11.07.2012  
**DESIGN REVIEW**  
**REVISIONS**  
DPD Project Number: 3012437

12 AVE ARTS

**We are returning to apprise the board of further elevational development, and to present solutions to the conditions identified at the initial Design Review meeting.**

**B. SECOND LEVEL MARQUEE**

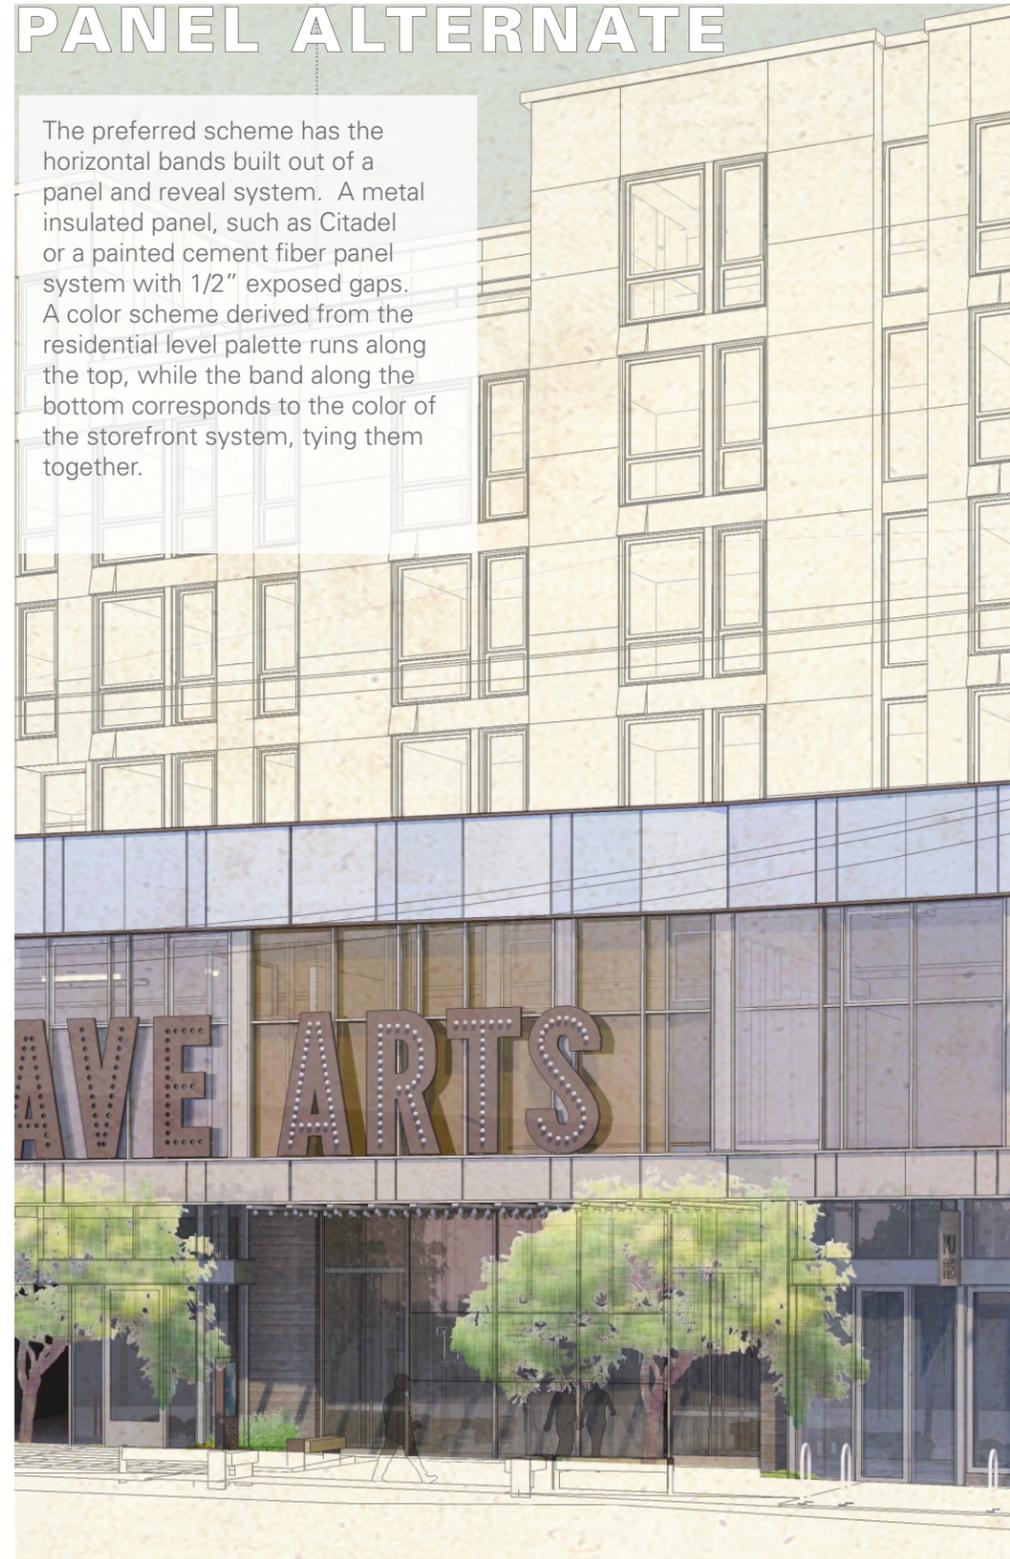
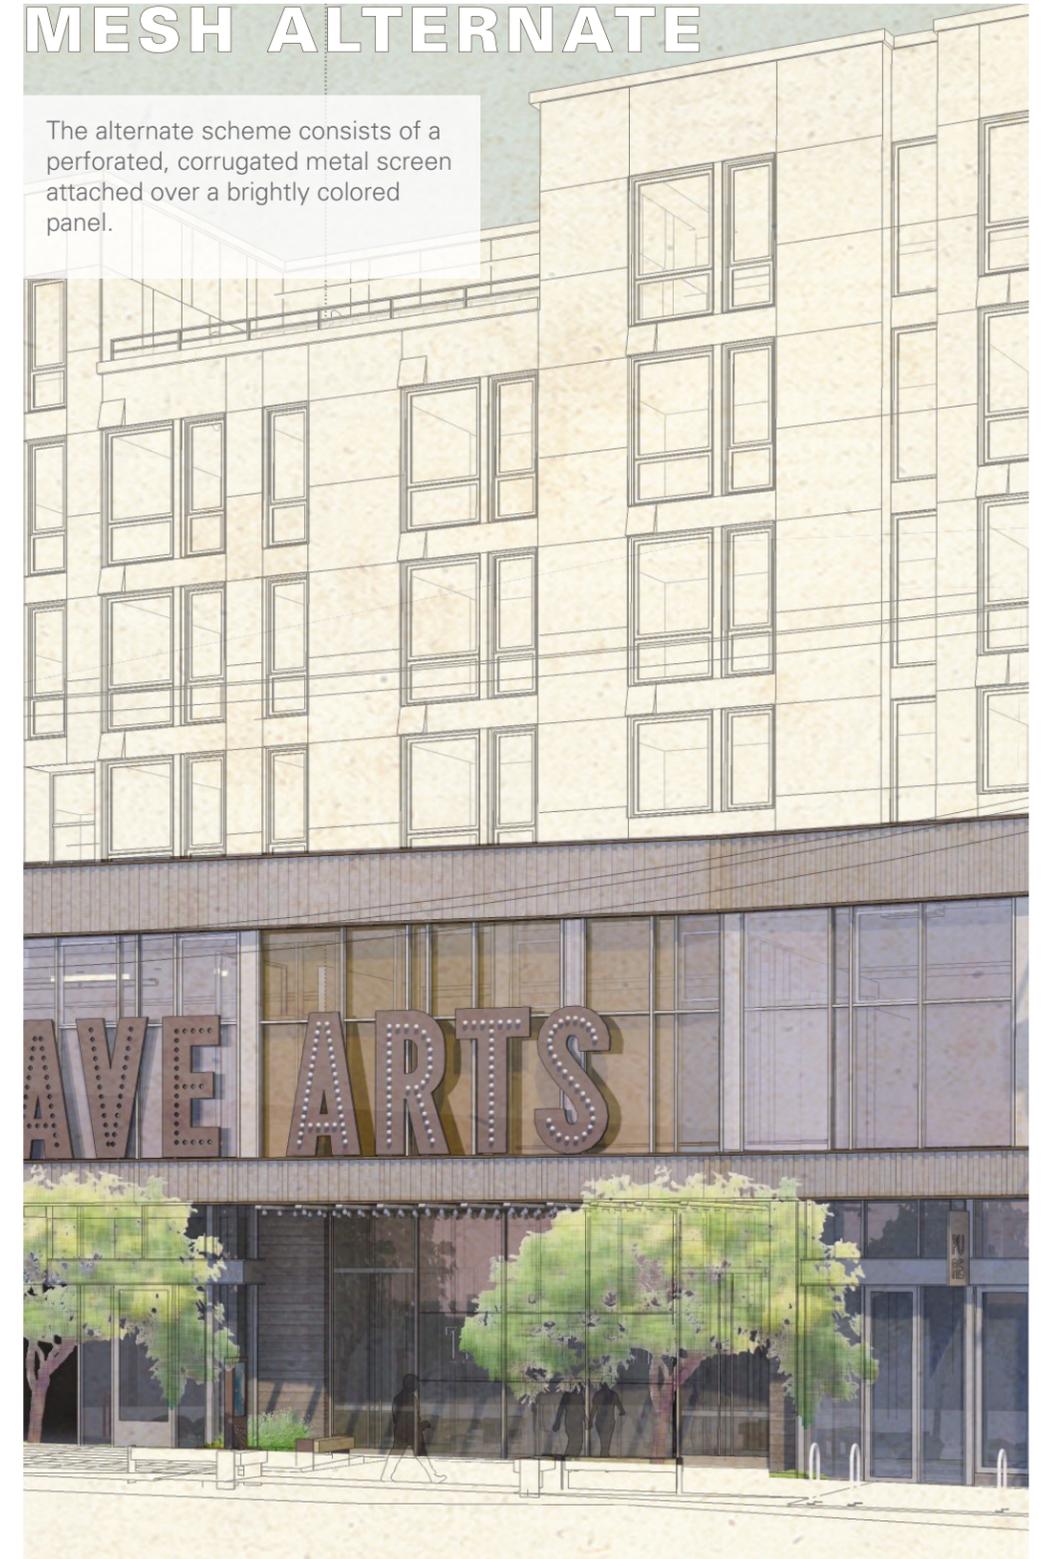
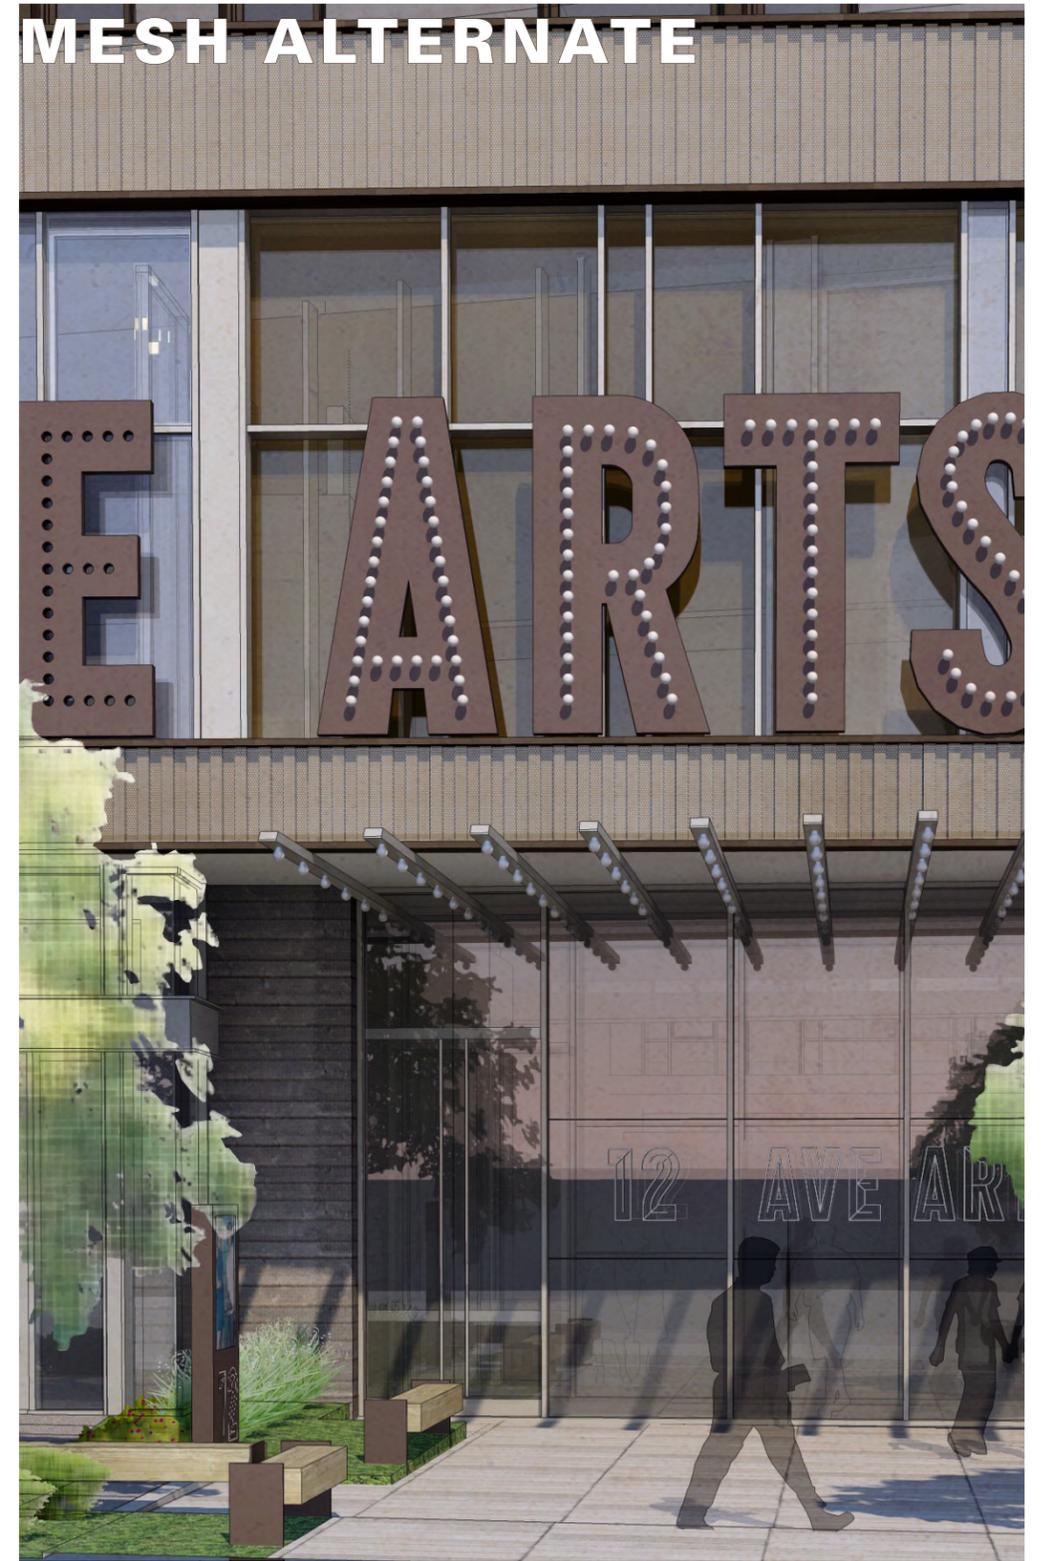
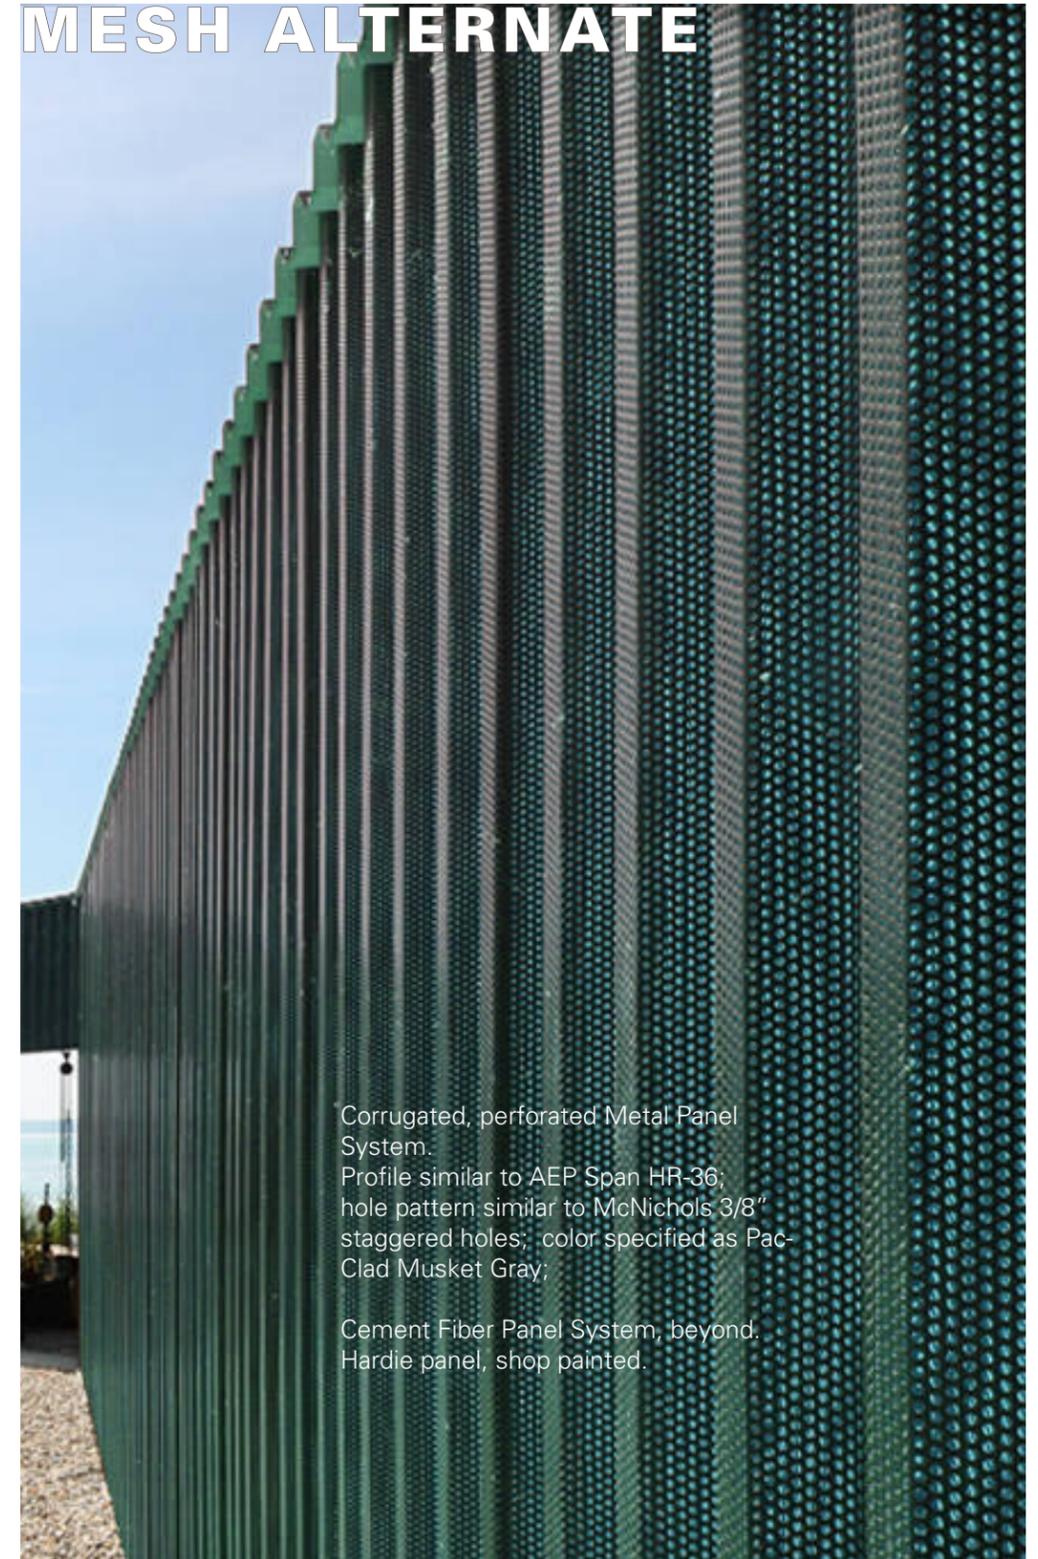
B. SECOND LEVEL MARQUEE  
Changed from a curtain wall system of continuous glass, to storefront system with a continuous band of siding above and below. Two alternates are presented, we would requesting approval of both for the development team to choose.

The preferred scheme has the horizontal bands built out of a panel and reveal system. A metal insulated panel, such as Citadel or a painted cement fiber panel system with 1/2" exposed gaps. A color scheme derived from the residential level palette runs along the top, while the band along the bottom corresponds to the color of the storefront system, tying them together.

The alternate scheme consists of a perforated, corrugated metal screen attached over a brightly colored panel.

# 1

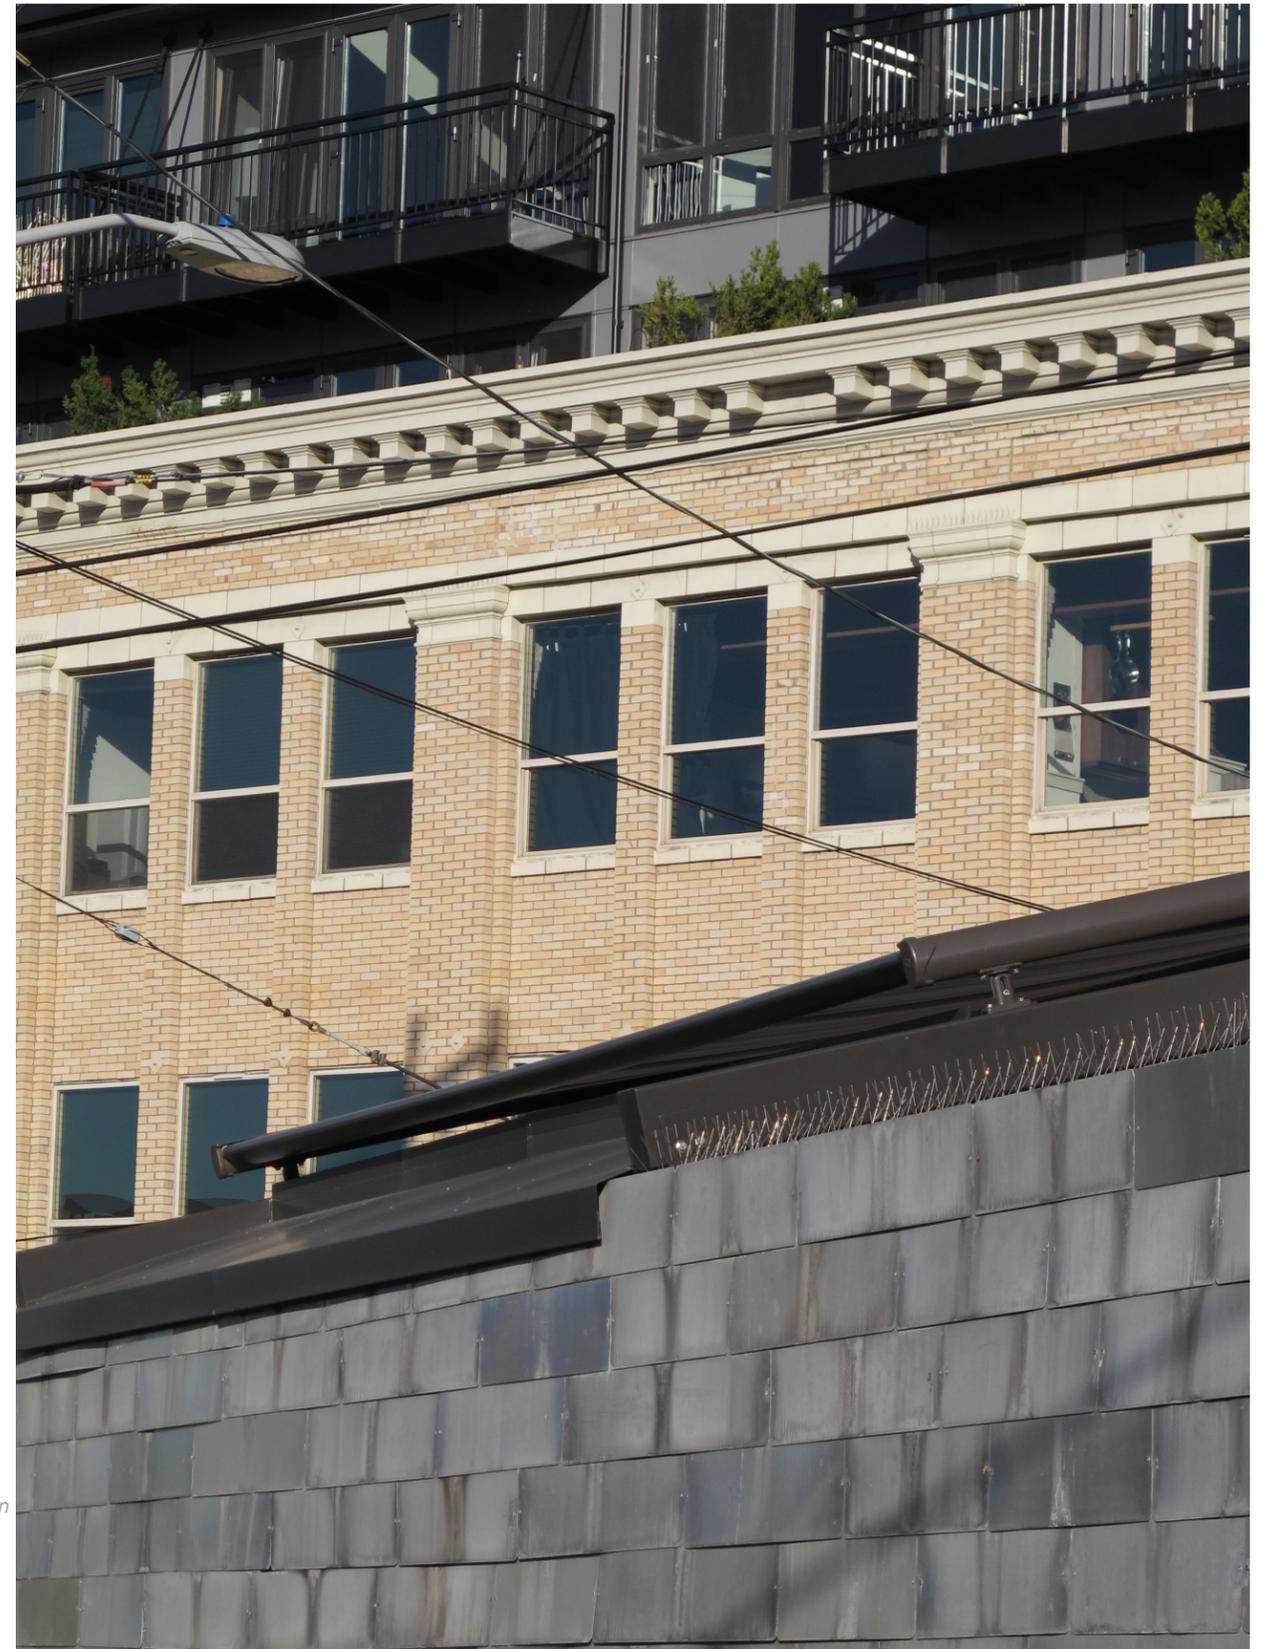
**The second floor horizontal band should be refined to appear more as a bold, continuous ribbon. This should be achieved with:**

**a) fewer layers of mullions and fewer facets to create a simpler band;**

**b) modifying the color of spandrel glass panel, glass and window mullions to appear more cohesive and less disjointed; and**

**c) design and provision of consistent interior window coverings with controls.**

As the Design Review Board correctly understood, the intent of the second floor ribbon is to separate the public spaces of the ground floor from the private residential spaces above. It is there to be bold and continuous, and we appreciate the Board's direction to further distinguish this element from the surrounding building. To that end, we have contained the glass top and bottom with a horizontal band, reduced the number of horizontal and vertical mullions, strengthened the vertical pattern, eliminated the spandrel glass, and addressed the interior condition.

At the interior office spaces, we have added a smooth soffit to the ceiling that extends 8' back from the window wall. This will ensure that additional treatment at ceilings by individual tenants are controlled at the perimeter, allowing for a consistent appearance from the street edge. Continuous strip lighting along the inside of the glass will further strengthen the concept.

The horizontal bands top and bottom strengthen the delineation between the uses above and below. The thin 30" band at the bottom retains the color of the storefront system — a ground plane from which the storefront grows. The more substantial 72" tall upper band adds color for interest, while cleanly masking the structure and the guardrail

The intent of the ribbon is to create a continuous texture that plays with light throughout the day and into the evening. "Facets" of deep vertical mullions and glass are what create this texture and this interest. In order to simplify the glazing system, we have emphasized the verticality of the system, utilizing 3" deep aluminum caps for the verticals and flat 1/2" caps at the horizontals, while reducing the quantity of vertical and horizontal mullions.

## 2. RELATIONSHIP BETWEEN FLOORS

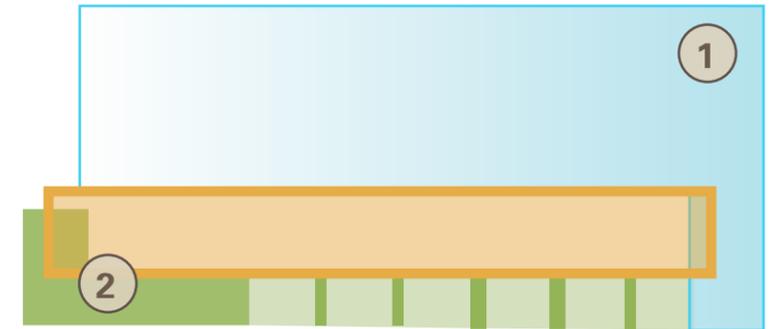
The relationship between the top and bottom floors appeared somewhat disparate and should be more harmonious. Prior to Building permit issuance, the applicant shall demonstrate a more cohesive design for the relationship between the upper and lower portions of the building.

We have created connections in terms of both the massing and the detail the building. At the Recommendation meeting, we showed how we connected the first and second levels to the residential building above at the south west corner. We also showed, but did not directly discuss, the connections that we are making at the northwest corner by taking the ground level concrete base up to the second level above.

1. connection of upper levels to lower levels;
- 2a. board formed concrete "anchor." This wraps around to the north side of the building, extends up to the second story, and is visible through the second story ribbon.
- 2b. Main entry utilizes the same concrete texture.
- 2c. Concrete columns behind the retail storefront system connect these

separate elements from one end of the building to the other. This allows the retail area to create a distinct appearance through the storefront system.

3. SERVICE AREAS

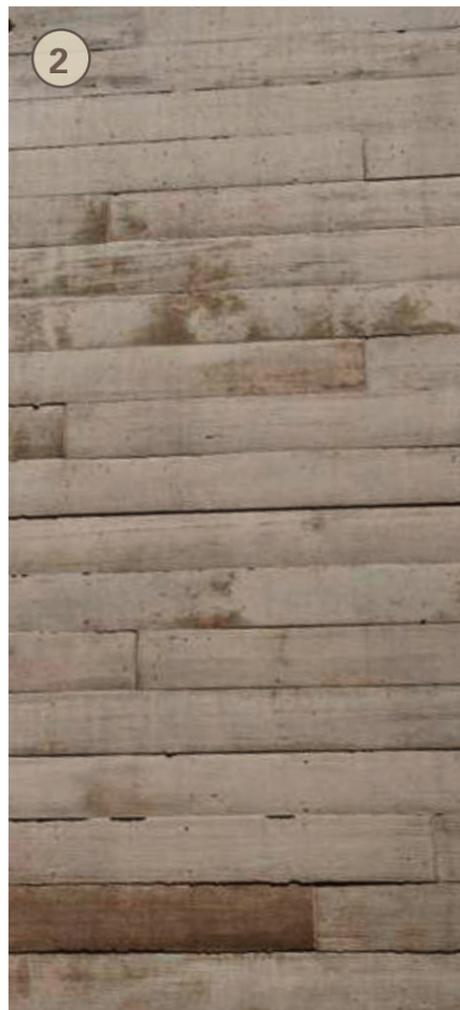
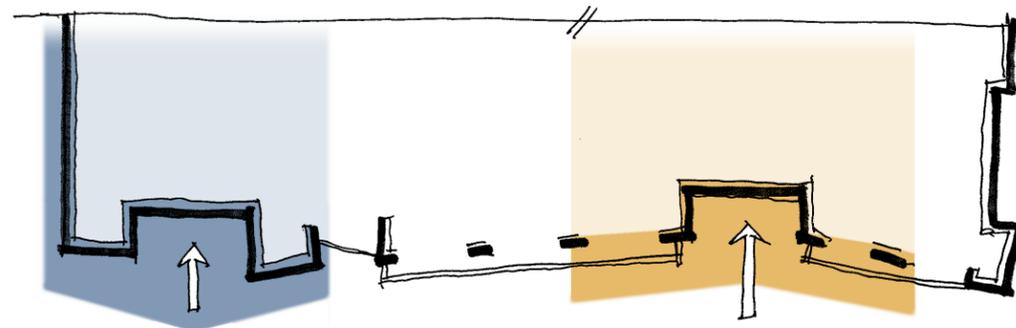
Relocate the service area to a location further away from the residential entrance and with minimal impact or presence at the sidewalk.

It is not possible to relocate the trash to another location on site while maintaining the city requirements for proximity to the street, and the requirements for curb cuts. Regardless, the design team studied an alternate location and an alternate orientation which are included in the appendix.

1. Enlarged the opening for the residential entry, and reducing the width of service space on the street front.
2. The material of the walls that surround the 12th Avenue face of the trash room has changed from Sandstone to a board formed concrete. This creates a highly textured tactile experience for

3. Framing the inside walls of the driveway will be wood-textured walls composed of the boards extracted from the board-form process. This creates texture, character and interest to these small segments of blank wall, and at the same time creates the understanding that this is not the pedestrian part of the building. Furthermore, this use of material references the concrete base of the building on the one hand, and the heavy timber construction of auto-row era structures of the surrounding neighborhood.
4. Reduced the width of the door to the trash room to further de-emphasize what lies beyond and give strength to the break in the building pattern. Here, simple, functional doors are painted to match the dark bronze found elsewhere in the building, neither hiding, nor emphasizing the use.
5. Expanded the landscape buffer between the residential entry and trash room door. This further
